# TECH BULLETIN

**005**  
08/77

## SUBJECT: "B" Manifold and Stepped Valve Seat

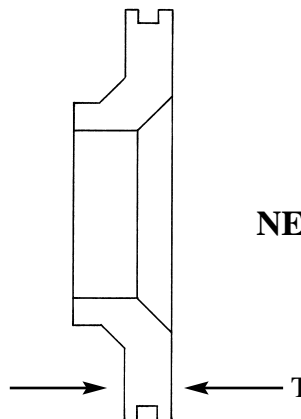
Beginning with May 1977, a back-up ring was added to the Valve Seat on all 10 Frame pumps. A thicker "stepped" Valve Seat was necessary to hold the added back-up ring and o-ring. A new manifold marked with a "B" with a deeper valve chamber was also necessary for this change.

It is important that parts are not interchanged from one design to another. However, with the use of PN 30452 spacer, the old Valve Seat with o-ring only may be used in the new style manifold-B.

The stainless steel discharge manifold (PN 30248) has a deep enough counterbore to permit either valve design.

### **OLD Valve Seat**

T = .157" (4.0 mm)  
PN 27350

### **NEW Stepped Valve Seat**

T = .197" (5.0 mm)  
PN 43046
